AMENDMENTS TO THE DRAWINGS

REMARKS

Title: Communications Spooler for a Mobile Robot Inventors: Pack et al. Atty Docket No. IRO-009 U.S.S.N. 10/811,316 Atty: CWStamos/ALJagenow Annotated Sheet

FIG. 2

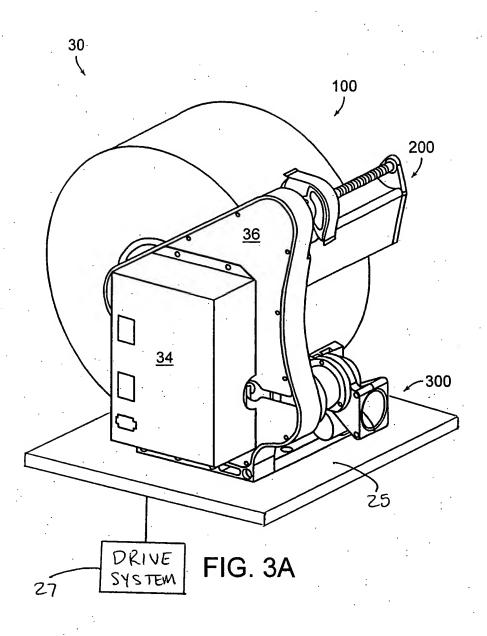
Applicant submits herewith four drawing sheets marked "Replacement Sheet," which incorporate amendments made to FIGS. 2, 3A, 3B, and 12. Applicant also submits four drawing sheets marked "Annotated Sheet," with amendments made to the drawings indicated in red thereon. In accordance with 37 C.F.R. § 121(d), amendments to the drawing are explained in the Remarks section of this paper.

With this Amendment and Response, Applicants hereby amend FIGS. 2, 3A, 3B, and 12 to provide numerical designations for elements depicted in the figures. Applicants hereby amend paragraph [0003] to correct a typographical error. Applicants also hereby amend paragraphs [0017], [0019]-[0021], and [0052] to more clearly describe elements depicted in the drawings and disclosed in the specification. No new matter is added thereby. Support for the amendments can be found in the specification and figures as filed.
